ADDENDUM NO. 2

Fire Suppression System / AWG Development
Town of Pearl River, Louisiana

DATE ISSUED: April 16, 2012 EES PROJECT NO. 1012
BID DATE: April 23, 2012

CONCRETE CURBING DETAIL

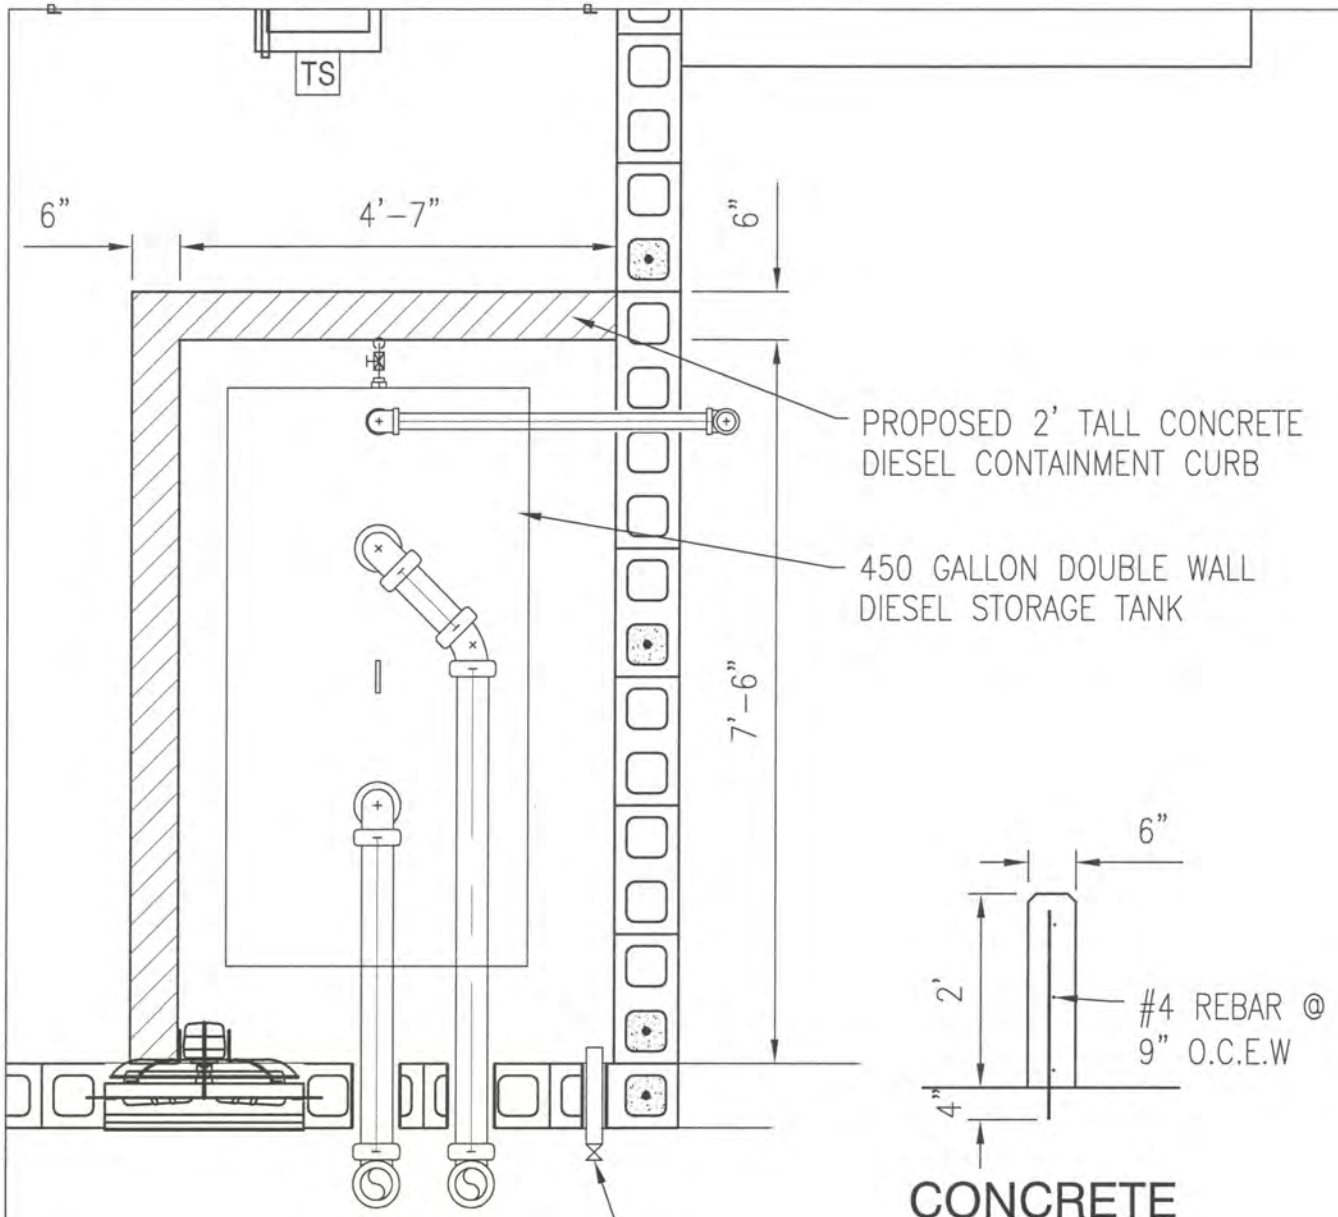
4. **Add** attached concrete curbing detail to Sheet M02.

SHEET: A04

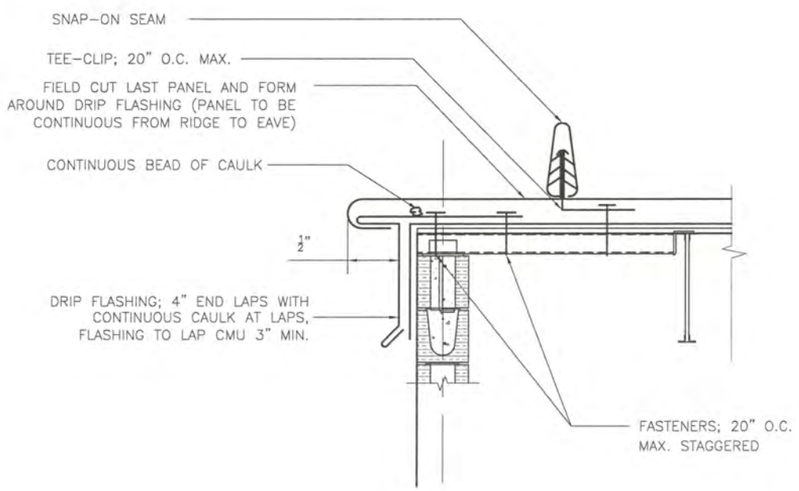
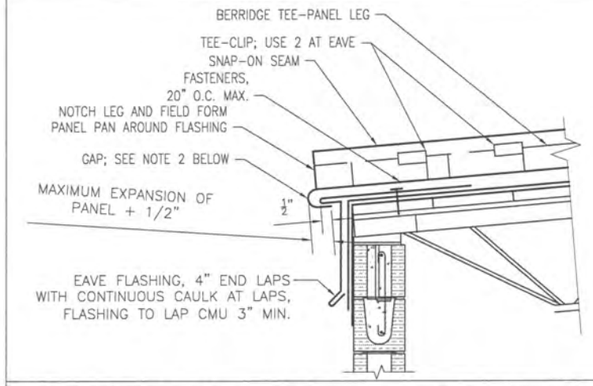
1. **Change** section callout from "1/A02" to "1/A01".
2. **Change** section callout from "2/A02" to "2/A01".
3. **Change** section callout from "3/A02" to "3/A01".
4. **Change** callout in section 2/A01 which reads "Steel Roof Deck" to "Standing Seam Roof Deck".
5. **Remove** reference to 2x4 stripping and **Replace** it with zee rib clips stripping at 12-inches on center.
6. **Add** the following note on this drawing:

"Note: Contractor to provide a roof system complying with FM Global Assembly No. 522-0-0. Insulation to be equivalent to a R16 value."

Engineer's Note: Modify all drawings to comply with FM Global Roof Assembly No. 522-0-0.

NOTE: ROOFING SYSTEM TO COMPLY WITH FM GLOBAL ROOF SYSTEM 522–0–0

WELDED TANK
FLOOR DRAIN DETAIL

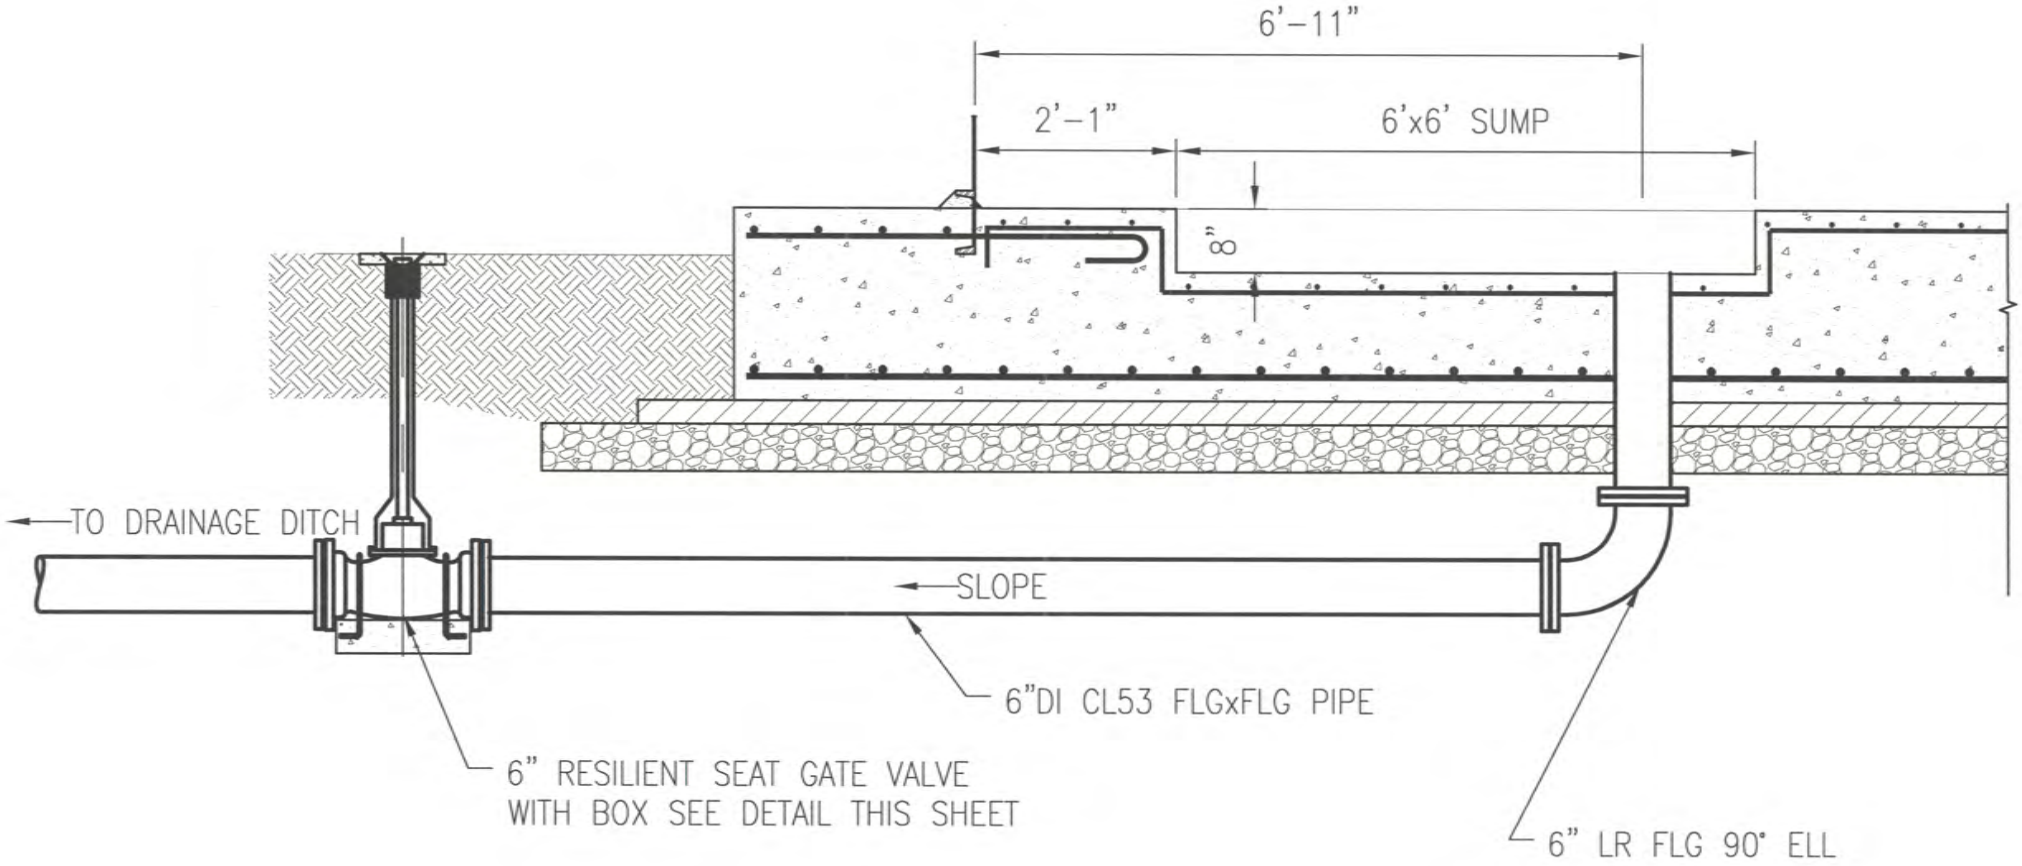
Remove floor drain detail and **Replace** with attached welded tank floor drain detail.

OVERFLOW PIPE

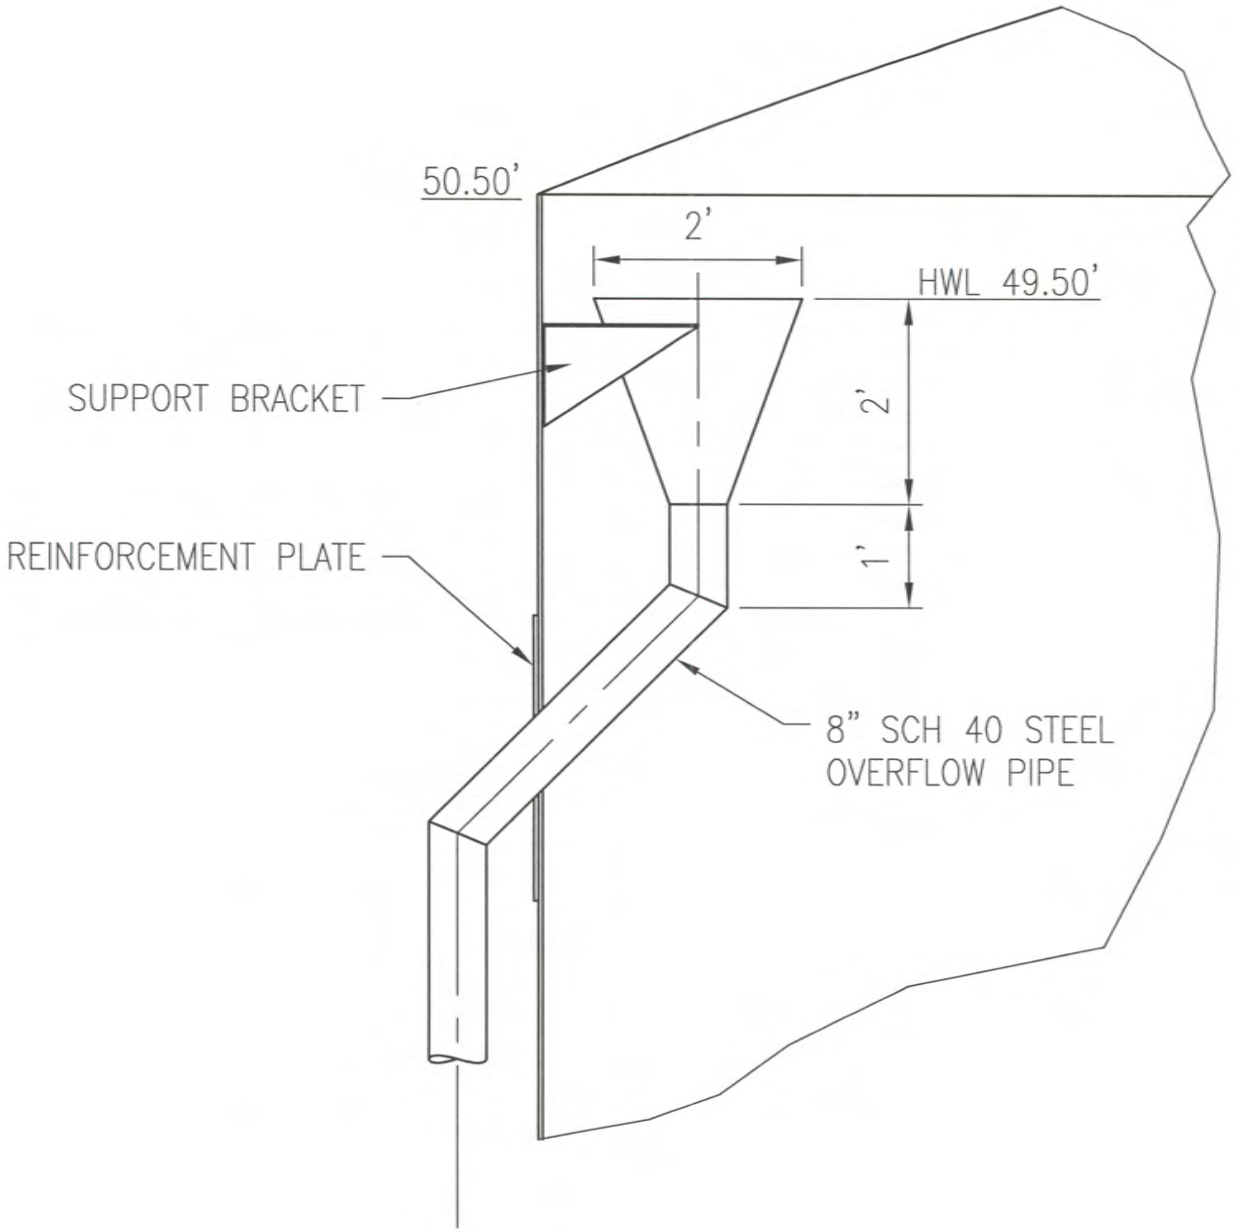
1. **Remove** overflow pipe detail and **Replace** with attached overflow pipe detail.
2. **Add** note which reads: "Provide 4'x8'x6" concrete splash pad with #4 rebar @ 12" O.C.E.W. under overflow pipe".
3. **Add** the following note to this drawing:

BOLTED TANK
FLOOR DRAIN DETAIL

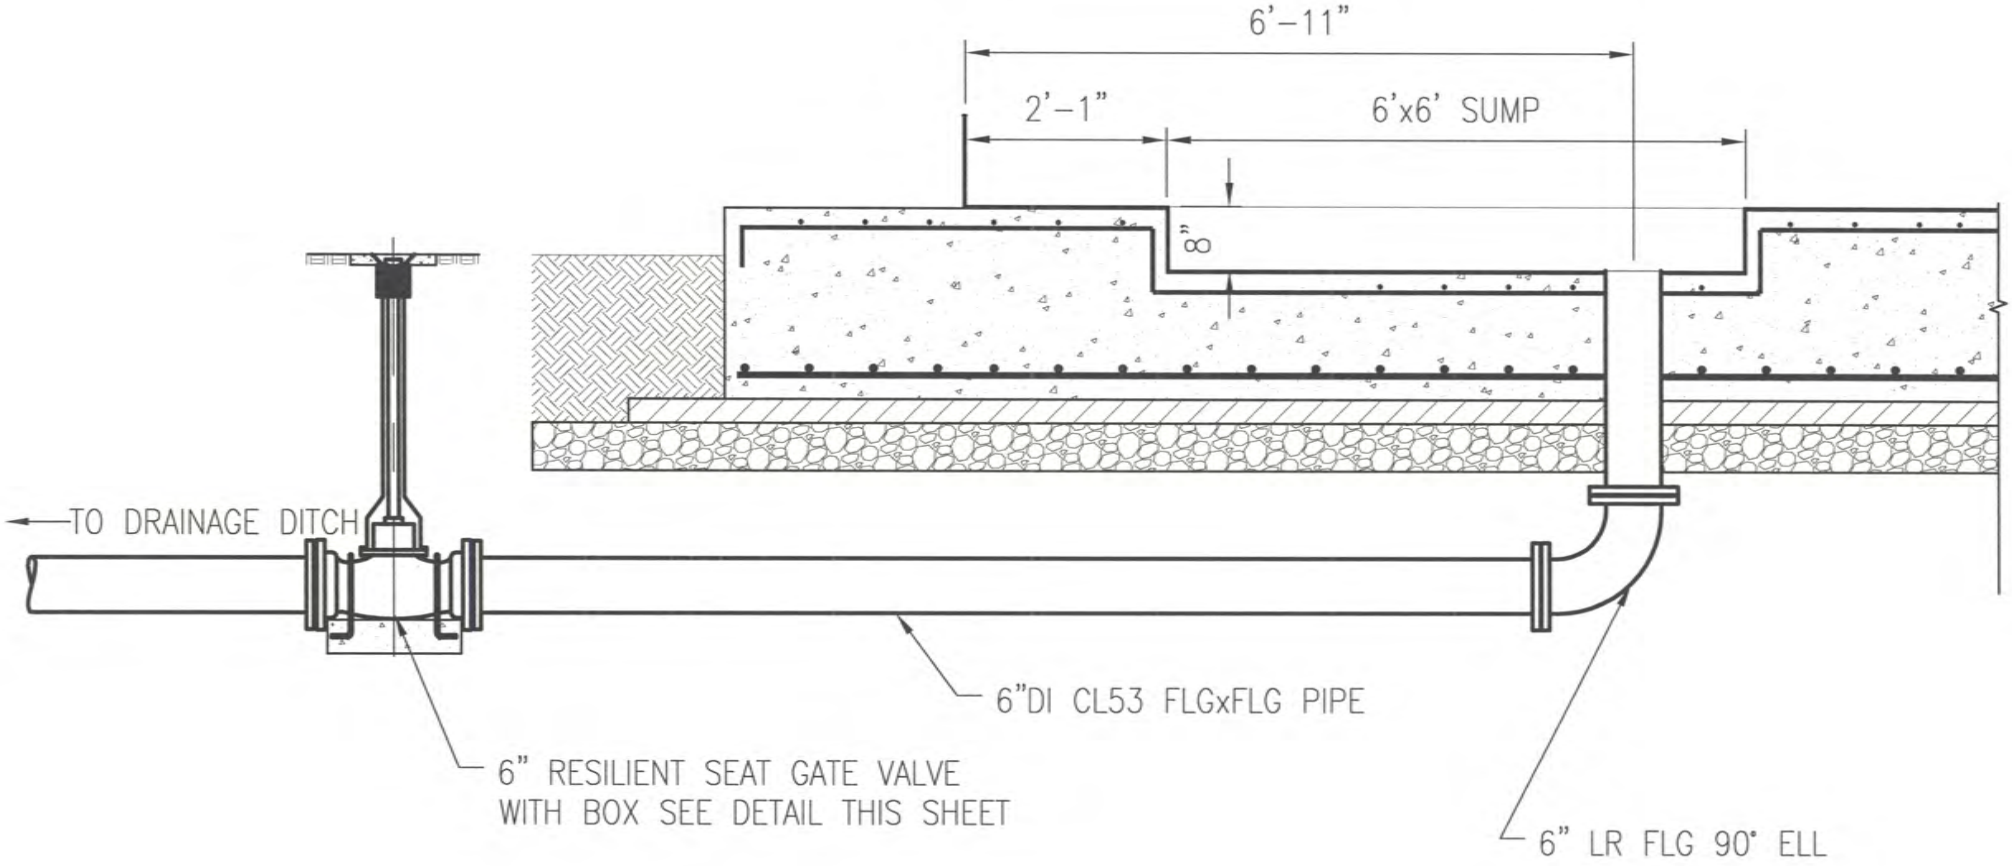
Remove floor drain detail and **Replace** with attached bolted tank floor drain detail.
